Wednesday 8th January, 2020

Re: Product Change Notification for Harwin packaging.

Left = New plastic cap, Right = Previous metal cap

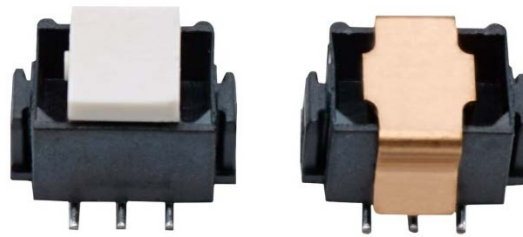
Please be advised that the pick and place cap used on male Datamate connectors (M80 Series) has been changed from a metal stamped cap to a plastic cap. This has been identified and implemented as part of our continuous improvement program at Harwin. The visual difference is as follows:

As you can see from the profile of the plastic cap, a small amount of additional height has been introduced, and changes to the settings on your pick and place machines may be required. Please also note, we use a selection of materials for the plastic cap which will result in either natural or black plastic, depending on availability.

The connector design itself is unchanged. Please note that we are no longer able to supply the metal cap once stock of the existing packaging is exhausted.
